Parker House Proposed Design Development December 2016

This document summarises how the Parker House redevelopment scheme has evolved during the period between attaining Non-material amendments in October 2016 (ref. 2016/4807/P) and the present date.

▲ Figure 1.4
Proposed window frame

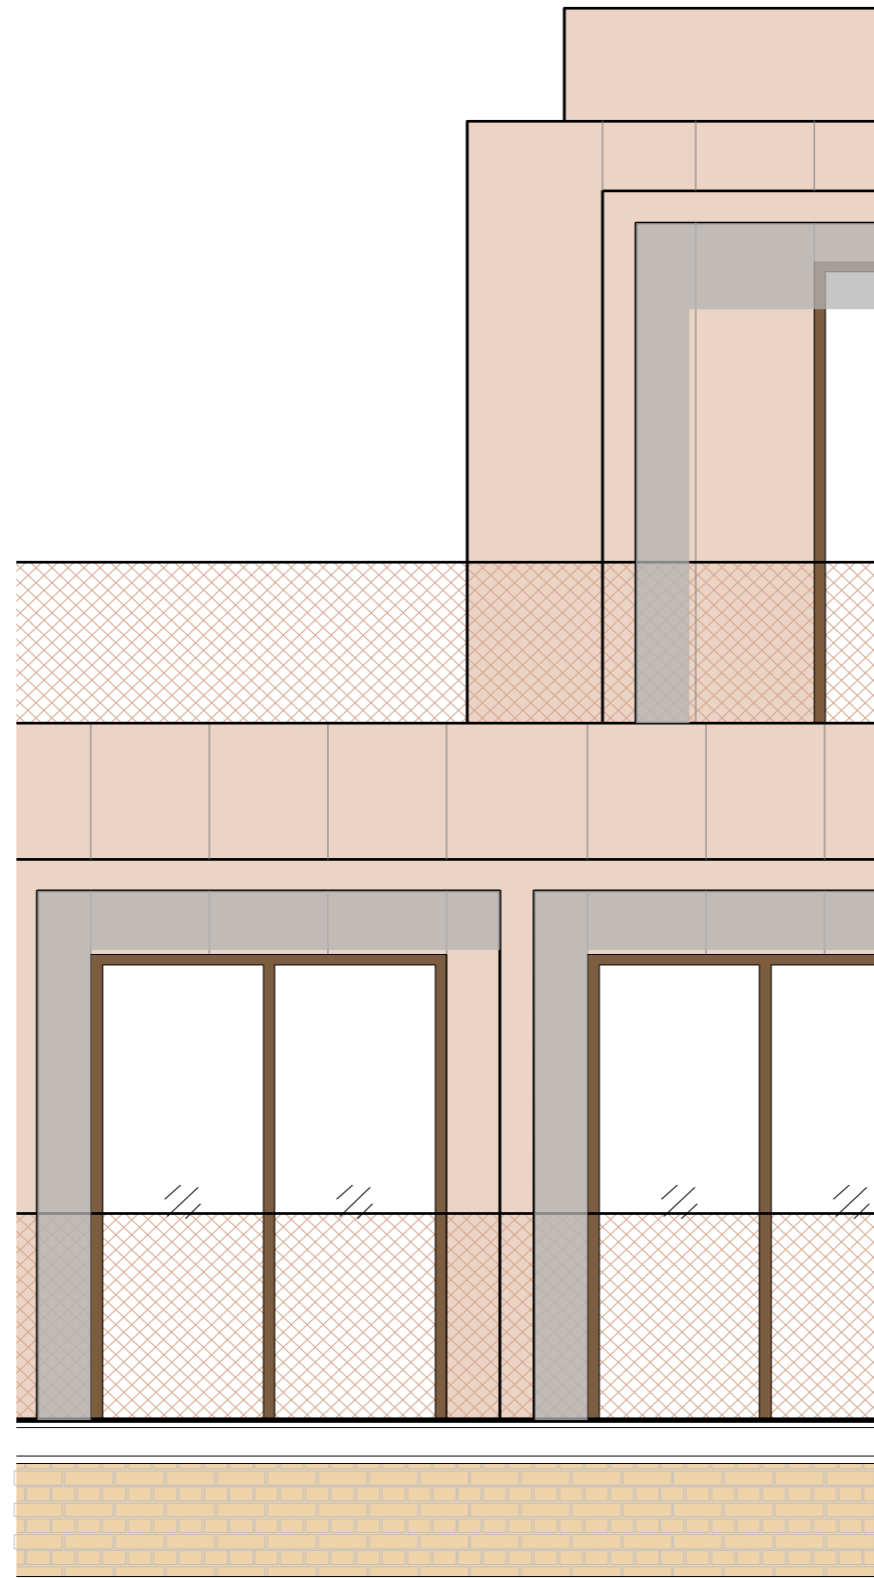
The proposed window takes its reference and its proportion from a traditional Victorian sash window, as seen locally on the facades of buildings along Drury Lane. By reducing the central mullion and the number of divisions with the glass, a greater percentage of natural daylight and sunlight is able to enter the building.

Reducing the profile of the timber sash is important for improving the daylight amenity and quality of living within the development. Retaining a white finish offers a level of cohesion best suited for a sensitive modernisation of a retained facade, keeping the proposal balanced within the rich variety of fenestration on Parker Street and the wider Seven Dials Conservation Area.

▲
Figure 1.5
Consented 4th & 5th Parker Street Elevation

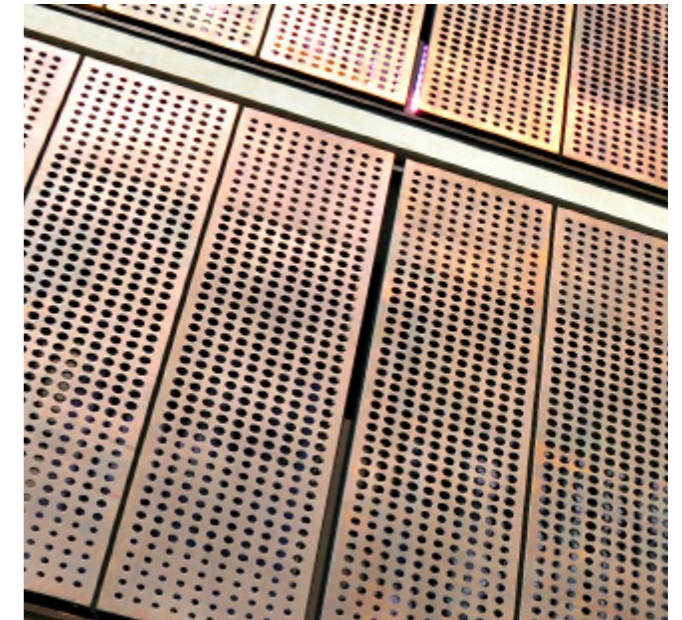
Through detailed design development of the building's envelope and external spaces, it is believed that a simple metal railing for the balustrades is more suitable for achieving the design intention rather than the perforated metal panelling, as currently consented.

The intention in the original consented drawings was for the balustrades to serve as mediators between the brick at lower levels, and the metal cladding at upper levels. However, following consultation with market suppliers, it has not been possible to find a suitable product that achieves the desired level of visual density with this approach.

Conversely, a thin, simple metal railing would not compete with the building, better allowing the architecture to be appreciated. Furthermore, this approach correlates with the heritage of the facade, with reference to the salvaged chimney ties and iron railings that previously served the parapets.
